Site & Open Space: HW Overall Comments

Dunstan East Peer Review
March 17, 2020

Building 1 Elevation

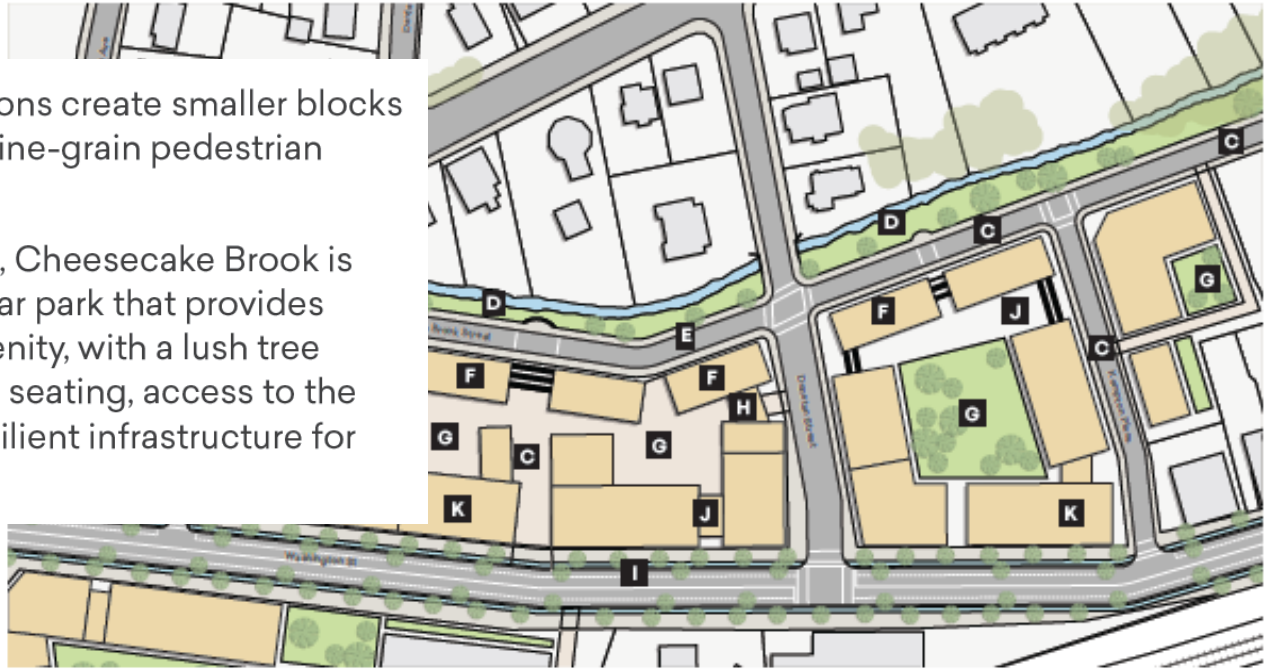
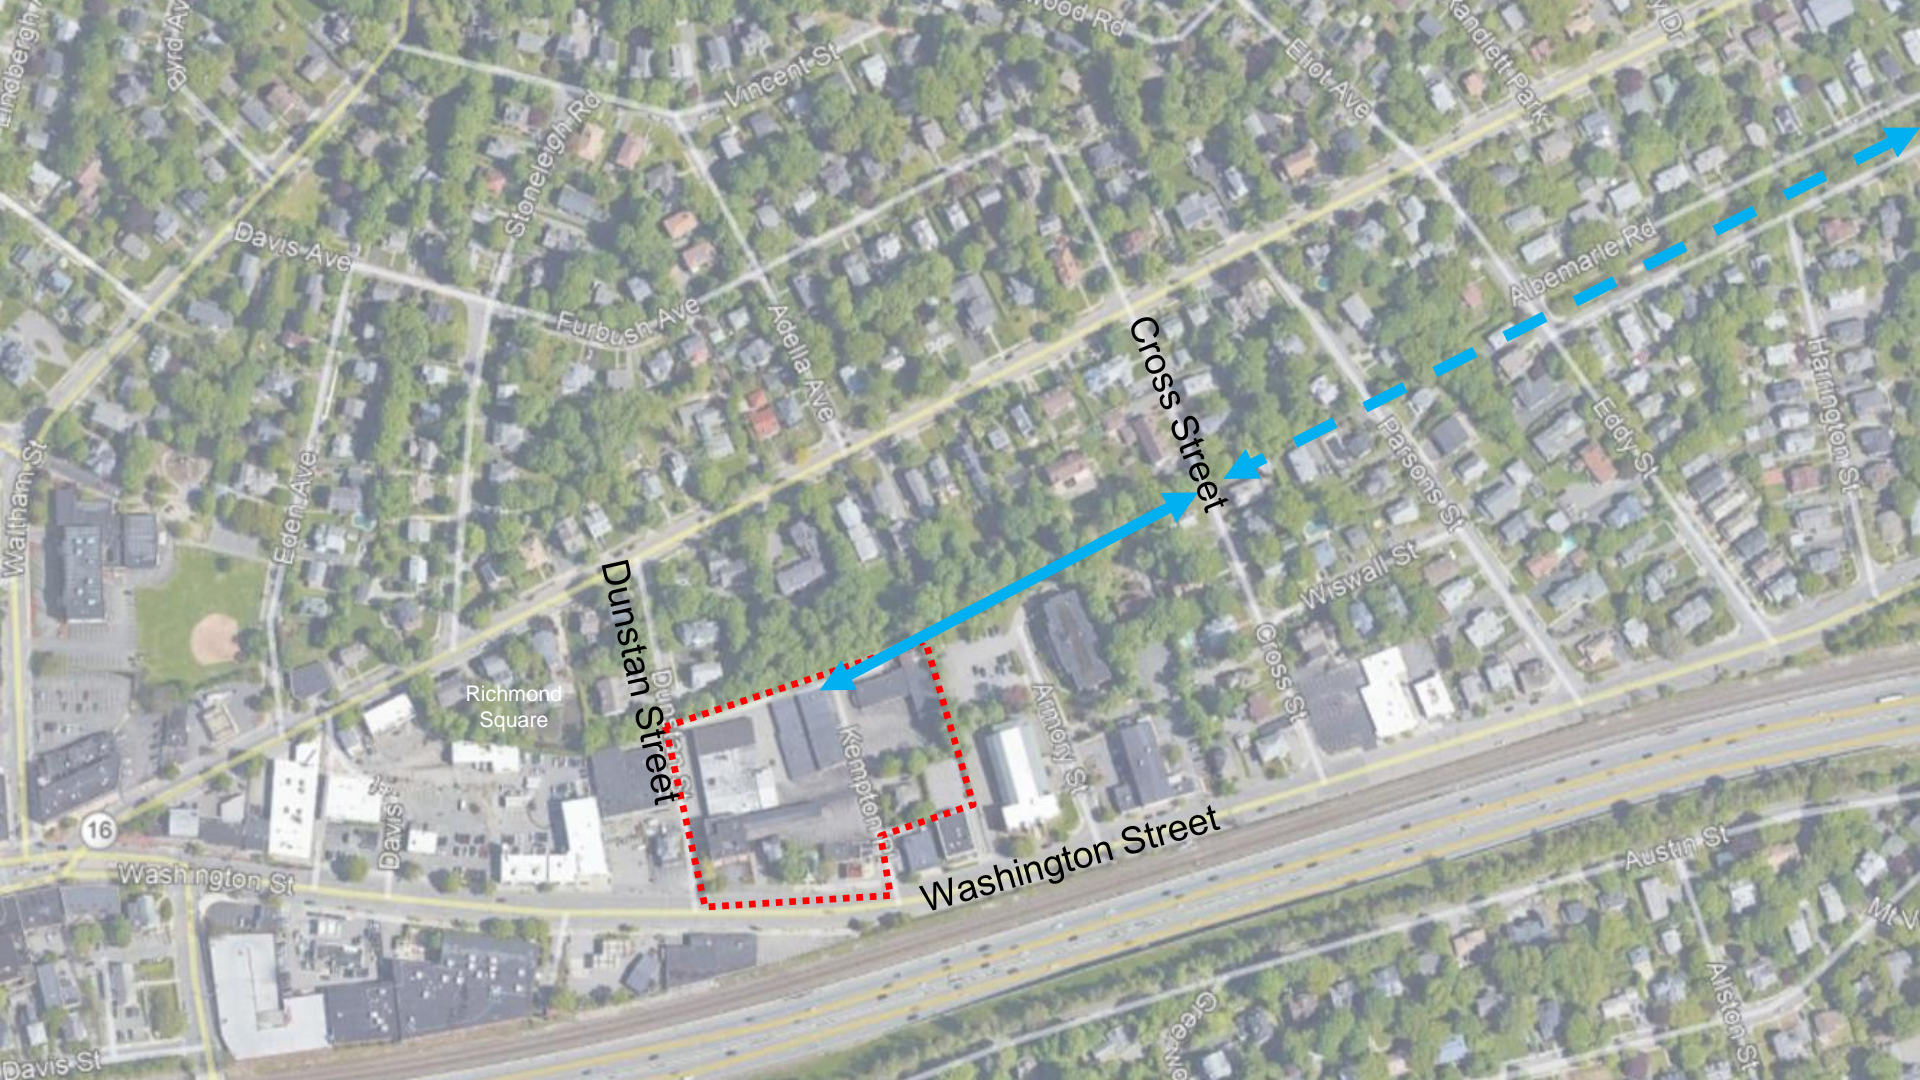
- Site Plan, massing, and building heights are generally consistent with the Vision Plan principle:
 - Breaks down megablock and provides walkability
 - Washington Street massing is appropriate
 - Increases permeability – Brook Drive & internal courtyard
 - Adds density and trees to existing impervious site.
- The gentle transition of Building 1 massing needs more discussion.
- Future street and/or trail connection to the east should be considered.
- Pickup/dropoff locations need coordination, especially Building 3.
- Add trees to streetscape, especially Kempton Place.
